Windstop Locking Lever

Vehicle Type: **Boxster/Boxster S**

Model Year: **As of '97 (V)**

Concerns: **Attachment of windstop middle section on roll-over bar.**

Figure 1

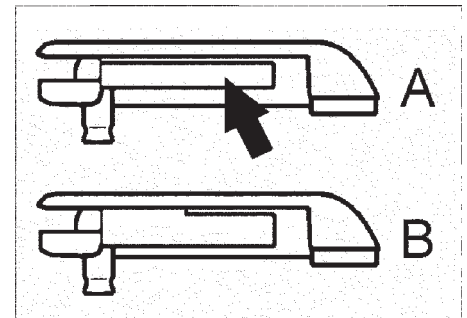
Information: Since March 12, 2004 production, the locking levers (right and left) for the securing of the windstop middle section have been changed. The locking levers are now available separately using normal parts ordering procedures.

Figure 1, Item A, shows the new version (right locking lever). The spring element of the new lever (arrow) is slimmer and more flexible compared to the previous version (Item B).

In case of complaints, the two locking levers (right and left) are to be replaced and not the windstop middle section.

Figure 2

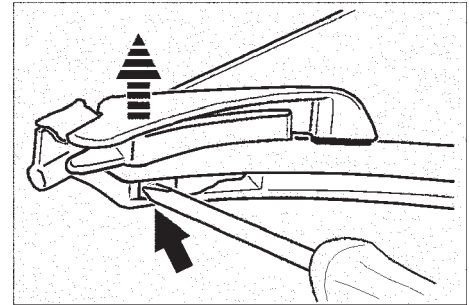
1. **Removing locking lever** (Figure 2). Using a small slotted screwdriver, disengage the locking lever by pressing down the axle and pull the lever out of the windstop frame.
2. **Installing locking lever.** Audibly engage the new locking lever in the windstop frame.

To prevent a reduction of pre-tension force in the engagement connection, the locking lever should not be repeatedly disengaged from and engaged in the windstop frame.
